Colorado Department  
of Public Health  
and Environment

Re: Colorado Radioactive Materials License # 317-02, Response to NRC Geologists  
Report Regarding Groundwater at the Hecla-Durita Site

# TECHNICAL REVIEW OF HYDROGEOLOGIC CONDITIONS AT THE DURITA SITE, MONTROSE COUNTY, COLORADO

Photo 1 – Outcrop of Mancos shale in an arroyo east of Durita site showing weathering to soil consistency and absence of vertical fractures.

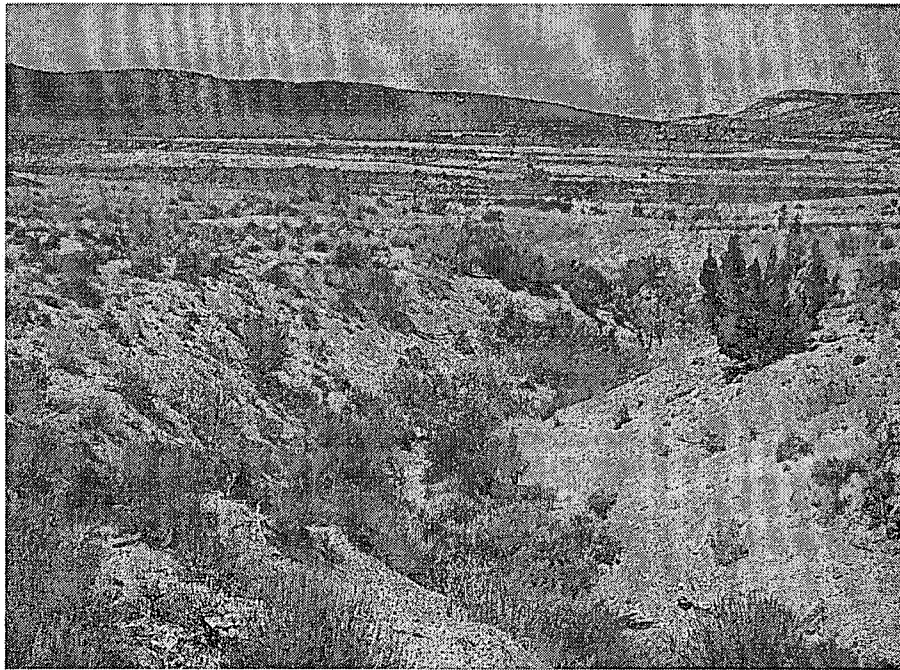
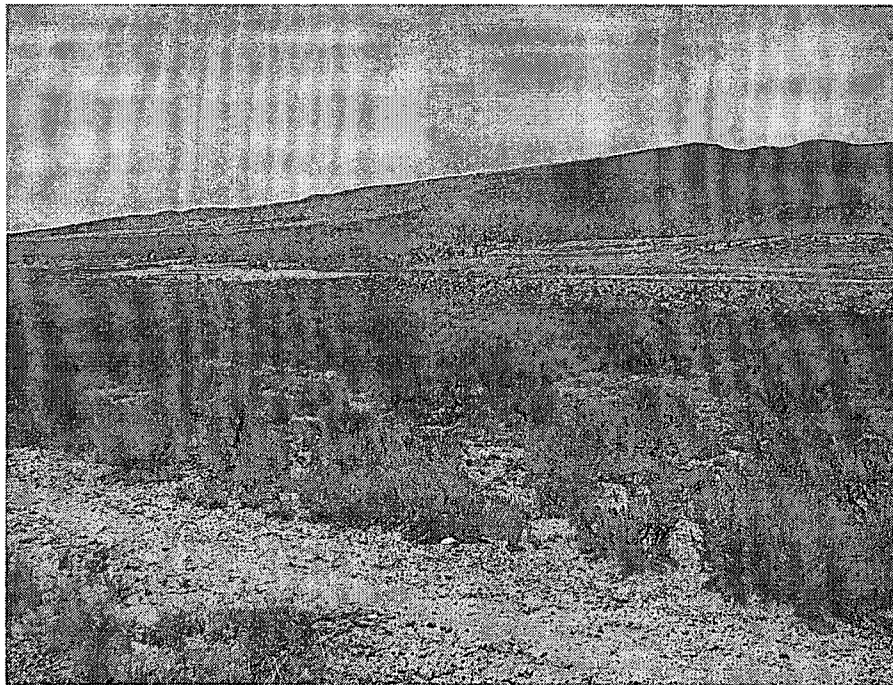
There is substantial information to show that these preferential pathways are not likely to exist. The NRC raised a concern that these pathways are possible based on their field observations during a site visit. The NRC made field observations of vertical fractures in the Km exposures of the cut slope on the west side of Mancos Hill and in the cut bank of Dry Creek northwest of the site. On page 10 and 11, section 4.2.4 of the report on the NRC site visit, the NRC states "Near surface bedrock was fractured..." "Thus, there is uncertainty in the ...hydrologic properties...of the Mancos". NRC staff noted heavy vertical fracturing in outcrops of the Km, leading them to speculate that systematic and vertically persistent pathways for rapid infiltration through the Km to groundwater exist. This scenario does not take into account the physical properties of the Km.

Therefore, these open fractures are surficial phenomena and are not persistent with depth. The Mancos Hill cut was made during site closure, and the Dry Creek cut bank is an actively eroding exposure that continues to slough to fresh surfaces; neither exposure is old enough to have weathered to soil. With time the shale slakes to finer fragments and finally to a clay soil. As the exposed Km surfaces weather, the shale breaks down to a clay soil consistency; this weathering is evident in a number of relatively recent Km cuts around the site that are only a few decades old (see photos 1 and 2). No open fractures are preserved in these surfaces.
